RE: Contract Documents
Town of Ayer, Massachusetts
Ayer Wastewater Treatment Facility – FY2018 Improvements
Contract No. 18DPW07

ADDENDUM NO. 1

This Addendum No. 1 to the above referenced project modifies, corrects and/or supplements the original Contract Documents date March 2018 and shall become a part of the Contract Documents.

SK-E-2

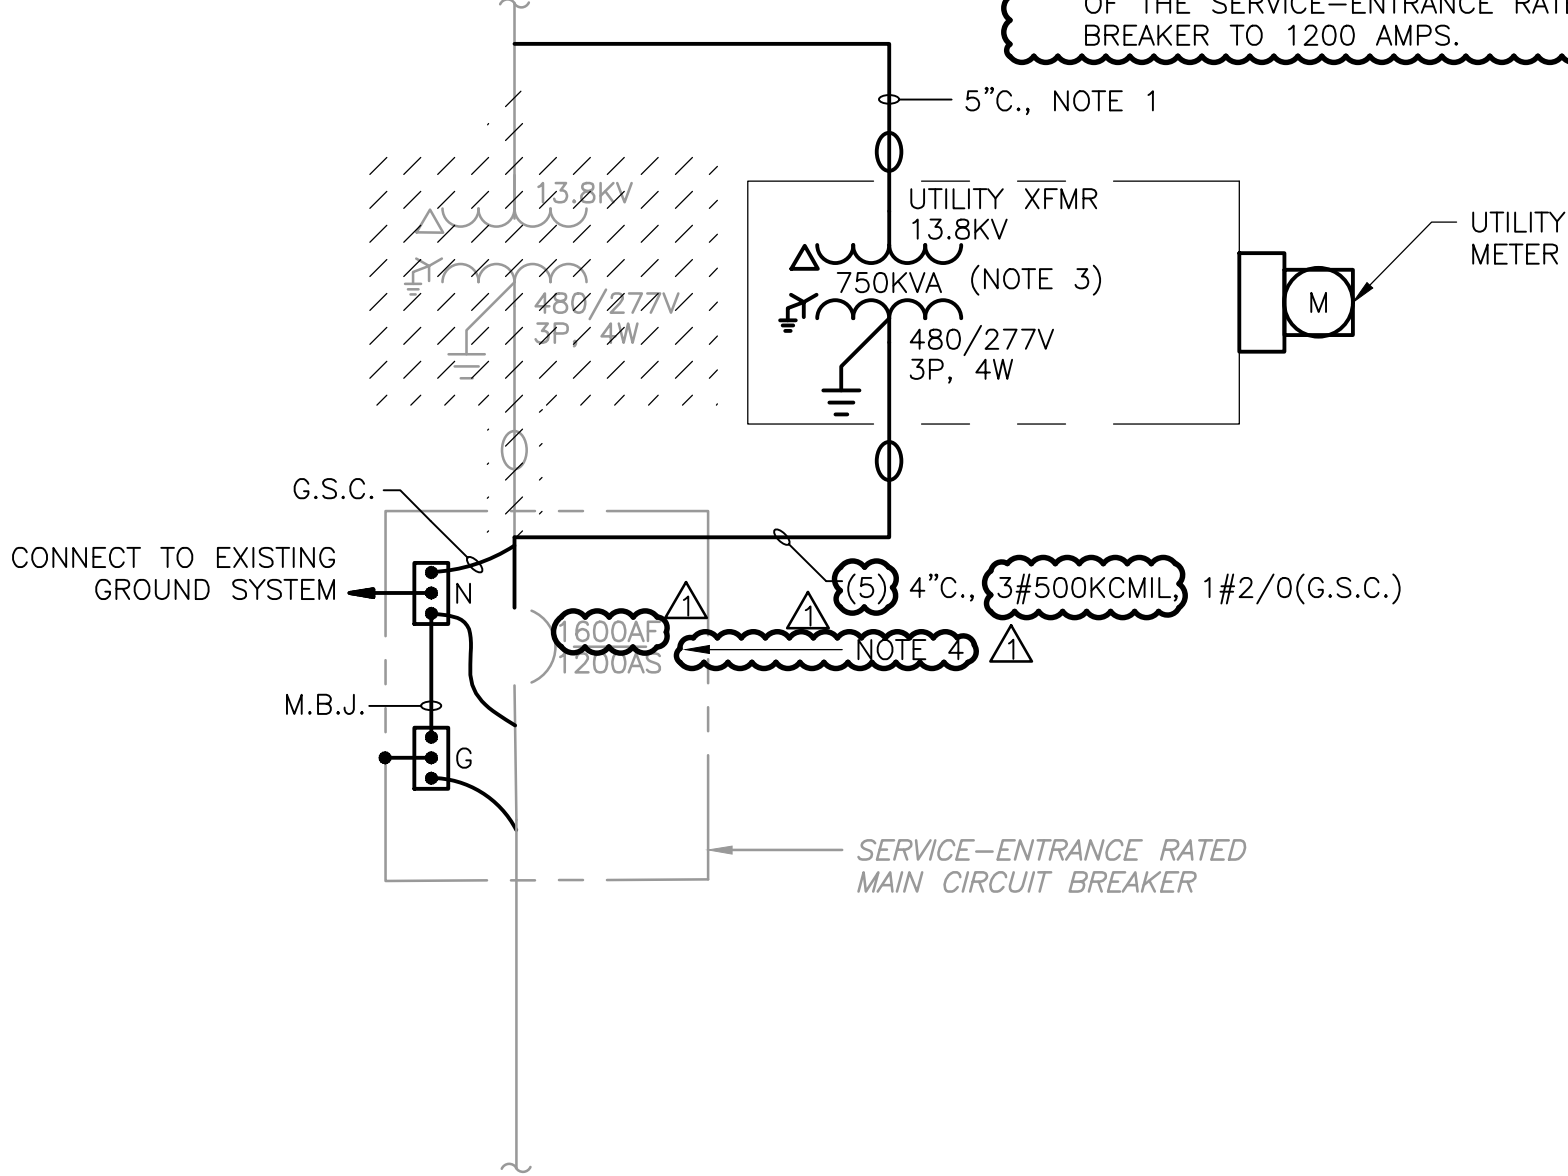
4. CONTRACTOR SHALL ADJUST THE TRIP SETTING OF THE SERVICE-ENTRANCE RATED MAIN CIRCUIT BREAKER TO 1200 AMPS.

Q3. The prints show 1200a, but from our pictures it seems the existing switch is rated for 1600a. Is the intent to just refeed with 1200A, and keep the 4th conduit a spare?

A3. Refer to Addendum No. 1 for sketches SK-E-1 and SK-E-2.
